Planning Commission Agenda Report

May 9, 2018
Item 6.a.

- SUBJECT:** P17-0907
- APPLICANT:** Robert Lyman, Johnson Lyman Architects
- PROPERTY OWNER:** Dennis Winslow
- PURPOSE:** Application for Design Review approval to retain an existing, approximately 1,042-square-foot, single-story single-family residence and to construct an approximately 2,404-square-foot, two-story, two-unit apartment building behind the existing residence and related site improvements.

- LOCATION:** 4722 Harrison Street
- GENERAL PLAN:** High Density Residential
- SPECIFIC PLAN:** Downtown Specific Plan – High Density Residential
- ZONING:** RM-1,500 (Multi-Family Residential), Core Area Overlay District

Figure 1: Site Plan

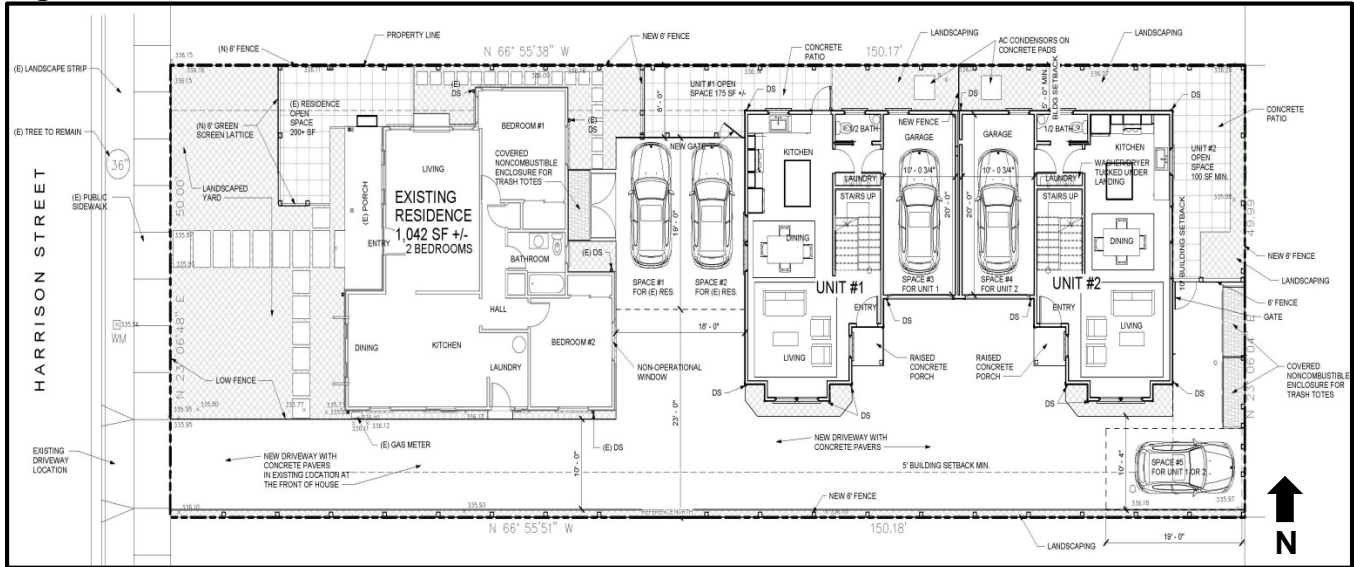
- Consider using enhanced/decorative paving and a mow strip for the project.
- Make any feasible modifications to improve access into and out of the parking spaces.
- Consider relocating the trash enclosures for Units 1 and 2 to allow Parking Space 5 to be

moved to the east and provide more maneuverability for Parking Space 4. Also consider taking a foot or two off the front of the ground floor of each new unit to improve on site maneuverability.

- Consider adding additional trees on-site to mitigate the removal of the Heritage tree.
- Consider merging the rear yard open space of the existing residence with the proposed open space for Unit 1 to allow more open space for Unit 1. Consider enhancing or modifying the front yard landscaping to create private space within the front yard for the existing residence (i.e., fencing, low walls, enclosed patio, etc.).

- Decorative concrete pavers have been included throughout the new driveway/auto court area and the parking spaces.
- A site plan revision has been made to improve maneuverability that consists of combining and relocating the trash enclosures for the new units to the far eastern edge of the project site. This revision allows greater depth for parking space no. 5, allowing any vehicle utilizing that space to pull forward more than in the previous design, which in turn improves the maneuverability (specifically the back-up area) for parking space nos. 3 and 4. Revised turning templates have been provided to show the improved maneuverability (Exhibit B, Plan Sheet A6). (Note: The revised turning templates are based on a 2018 Ford Explorer.)

- Three additional trees have been provided on-site to mitigate for the removal of the Heritage tree.
- The open space of proposed Unit 1 has been increased in size by absorbing a portion of the rear yard area of the existing residence. A fenced yard, utilizing vines and a lattice/green screen, has been added at the front of the existing residence to provide private open space.

Figure 3: Proposed elevations

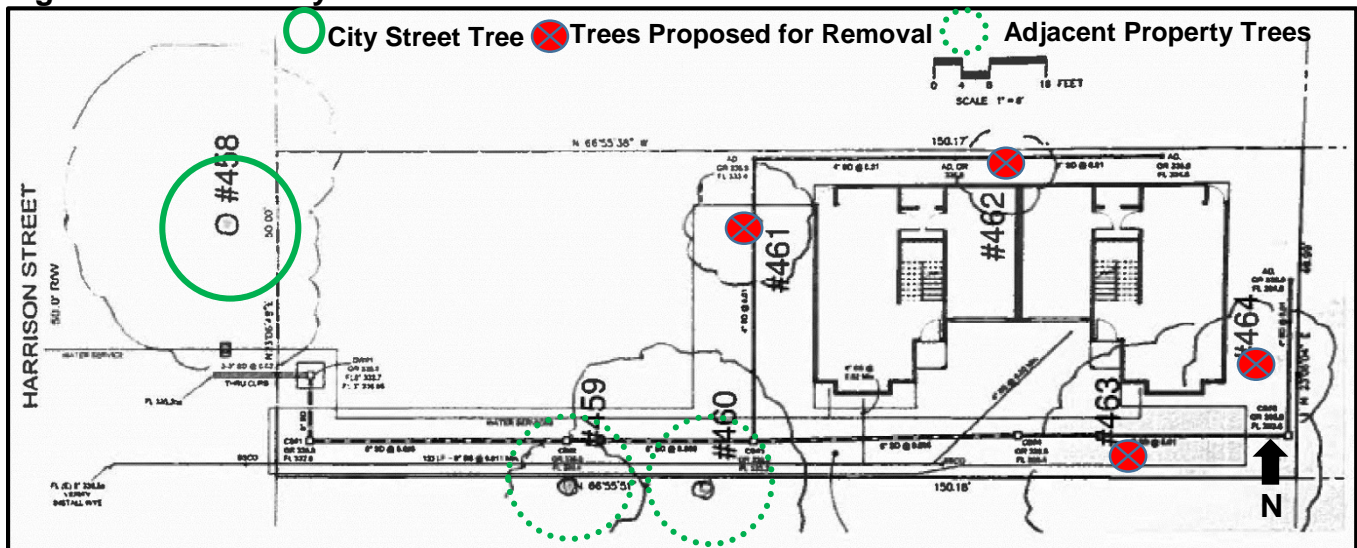
- Enhance the architecture of the apartment building to make it less plain. Consider following staff's recommendations in the agenda report (i.e., exposed rafter tails, more substantial window trim, raised porch with detailing, carriage-style garage doors, etc.) to address this issue and also look at incorporating those elements into the existing residence (light fixtures, front door, etc.) to improve its appearance and tie both buildings together.
- Consider introducing a third accent color on the buildings.

- The following architectural modifications are included in the revised design of the proposed units:
 - Exposed rafter tails at roof overhangs
 - More detailed window trim
 - A trellis over the garage doors
 - Beams added at gable-end eaves
 - The lapped siding on the second floor was changed to board-and-batten siding
 - The single body color was changed to have different colors for each floor
 - Carriage-style garage doors (see details on Plan Sheet A5 in Exhibit B)
 - A step was provided at the front entry porches
 - Shed-style awnings were added over two second-floor windows on the west elevation.

- The existing residence would be remodeled to be compatible with the proposed units, including:
 - New windows and doors
 - New siding to match the apartment building
 - New paint to match the apartment building
 - New awnings over the front window and side door
 - The existing composition roof would remain. The apartment building would match the roofing of the existing residence.
